added view jig to fix part 218		15-11-06	
A	added holes for LVDT	01-09-06	
ref.	note	date	signature
modifications			
240	X	EN 5083	1/6
ref.	pieces	mat. and treatments	scale
ref.	pieces	mat. and treatments	scale
General machining tolerances UNI 5307-63			
Dimensions	< 6	> 6-30	> 30-120
Linear Toli.	± 0.1	± 0.2	± 0.3
angular Toli.	± 1'	± 30'	± 20'
designed for: R.De Salvo			
LIGO PROJECT		draw. by: G.Gennaro-PROMEC	
title: HAM-OPTICAL BENCH		date: 4-02-06	
OLD TABLE		scale: 1/6	
ref. 226		detail from: A 1

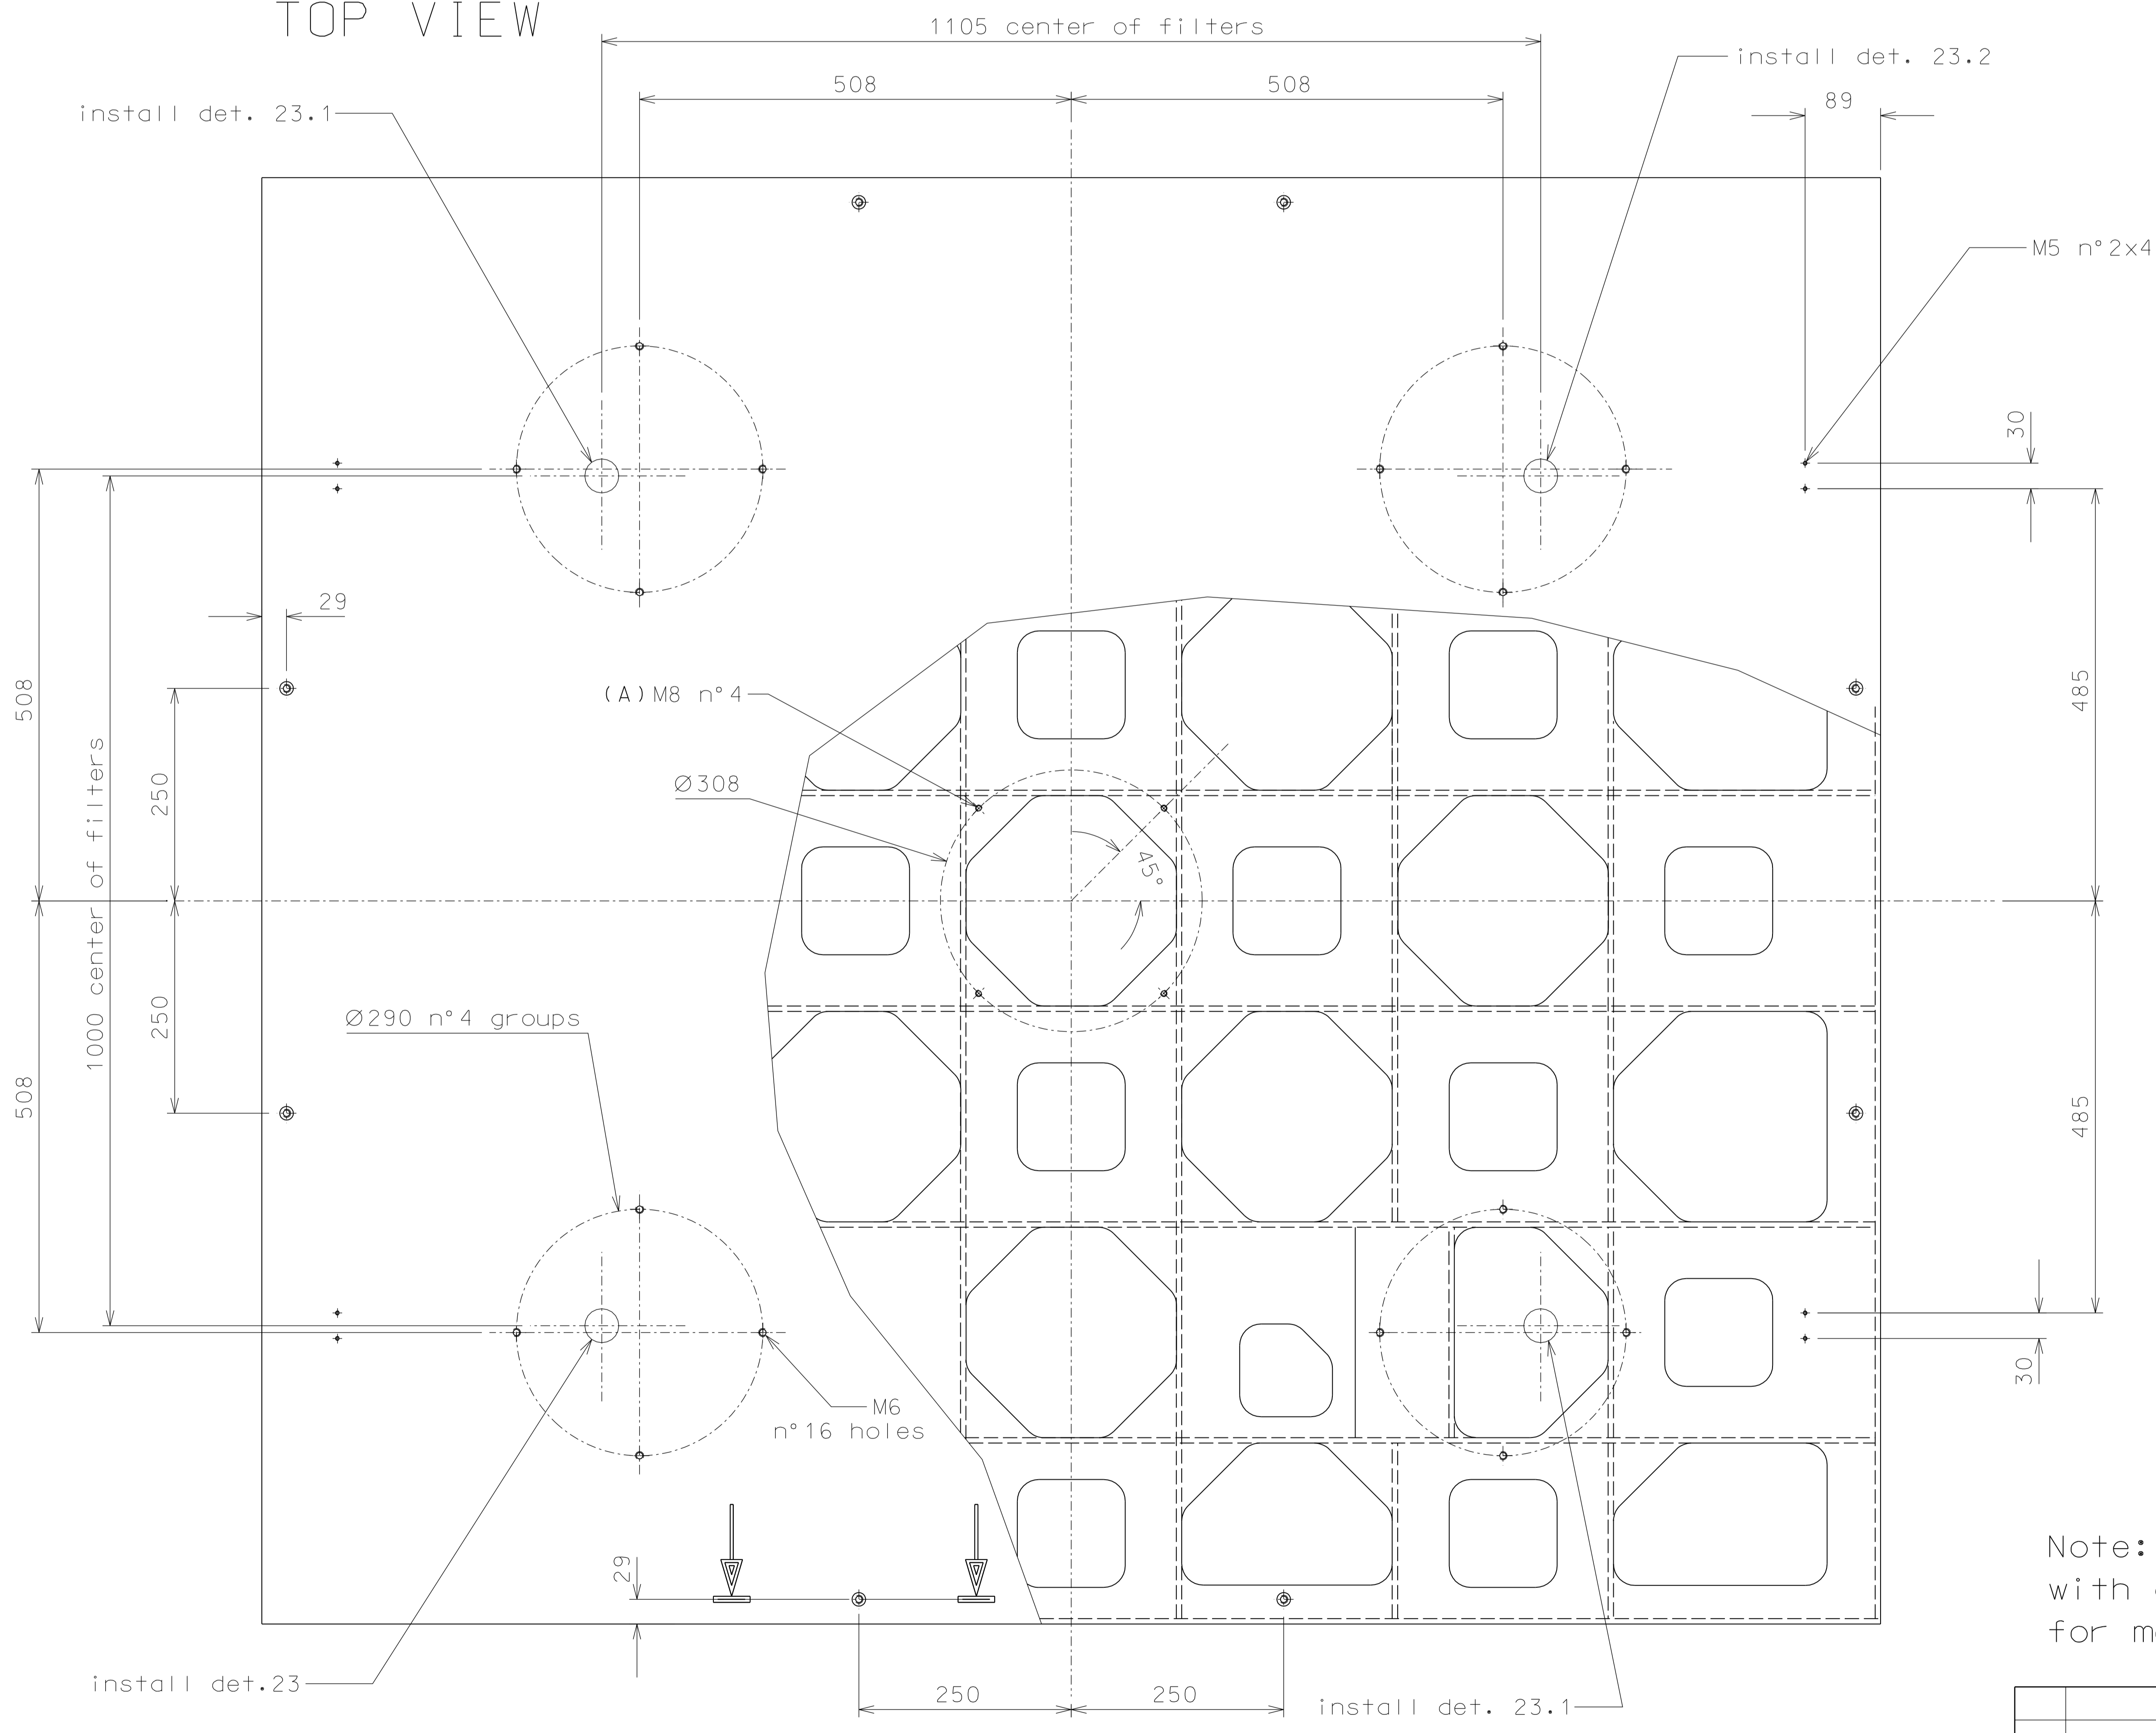
Note: Drawing of old table with dimensions of new holes for mounting on filter's system
